# Safety Evaluation Report

Renewal of the Facility Operating License for the  
Board of Regents of the University of California,  
University of California, Irvine Nuclear Reactor  
Facility

License No. R-116  
Docket No. 50-326

July 2016

**Figure 1 UCI Reactor Organization Chart**

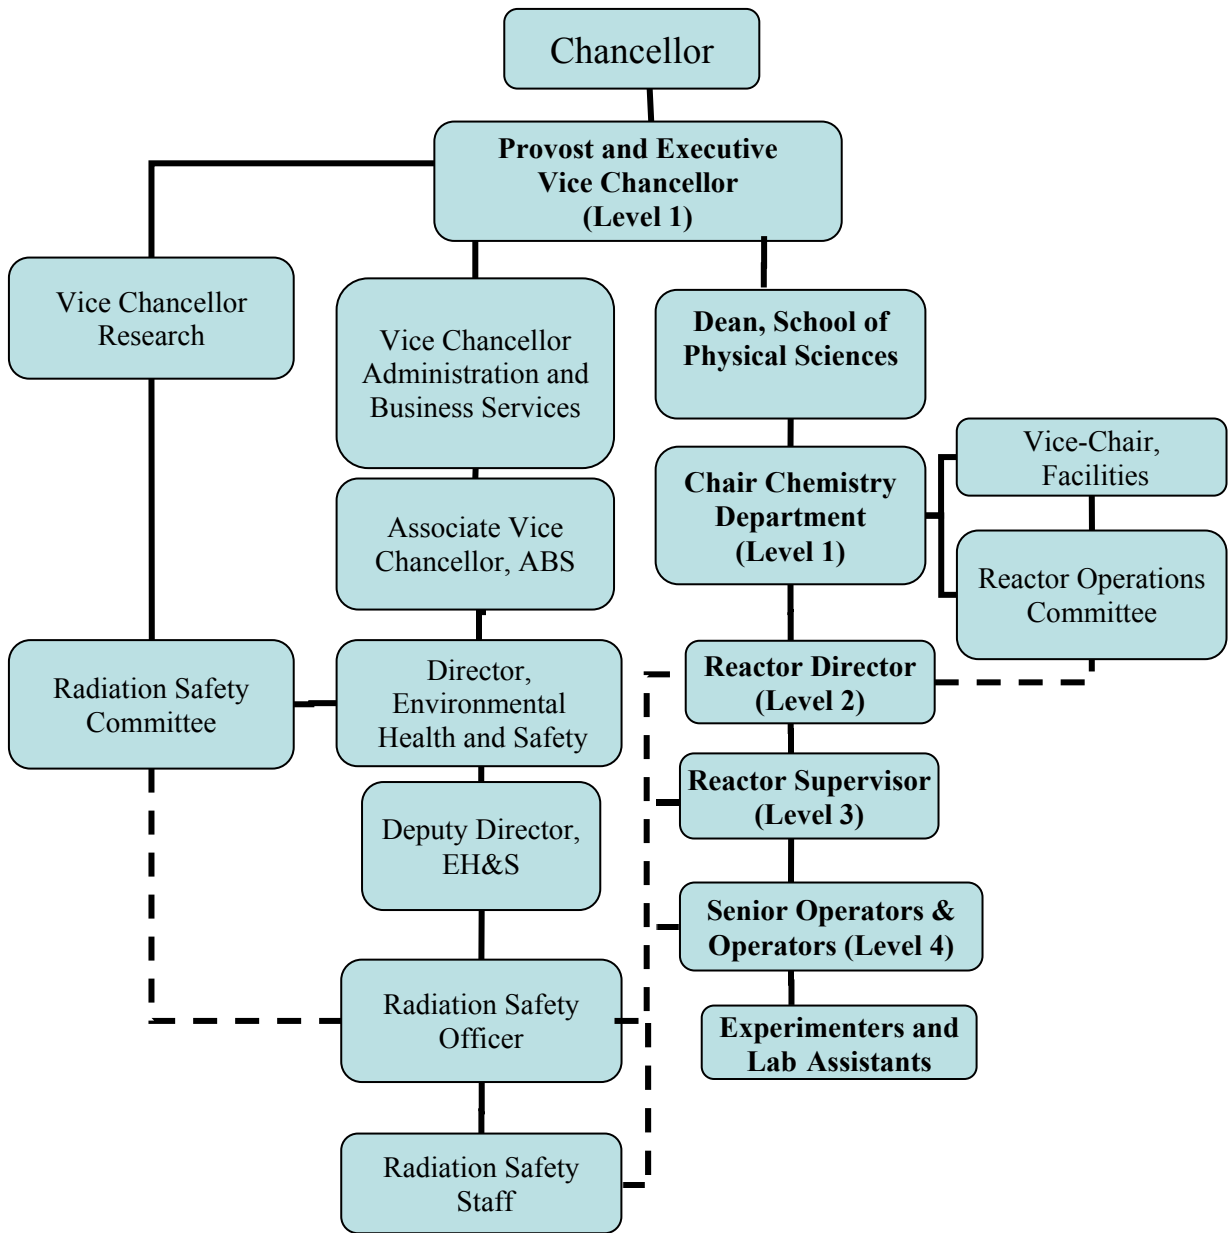
TS 6.1.1 ensures that the UCINRF organization structure is delineated, as described in TS 6.1.1, Figure 1. The NRC staff reviewed TS 6.1.1, Figure 1, and finds that Figure 1 identifies the reporting and communication relationships between the organizational units for the UCINRF and is consistent with the guidance provided in NUREG-1537 and ANSI/ANS-15.1-2007. On

the basis of the information provided above, the NRC staff concludes that TS 6.1.1 and TS 6.1.1, Figure 1 are acceptable.

TS 6.1.2, in conjunction with the organizational chart (Figure 1), presents both the responsibilities and organization of individuals associated with the facility. TS 6.1.2 shows the organizational responsibilities and arrangement for the radiation protection function. Figure 1 identifies the reporting and communication relationships between the organizational units. TS 6.1.2 also describes the organization and responsibilities of individuals in direct control of the facility. The NRC staff reviewed TS 6.1.2 and finds that the organizational responsibilities delineated in TS 6.1.2 are consistent with the guidance provided in NUREG-1537 and ANSI/ANS-15.1-2007. On this basis, the NRC staff concludes that TS 6.1.2 is acceptable.
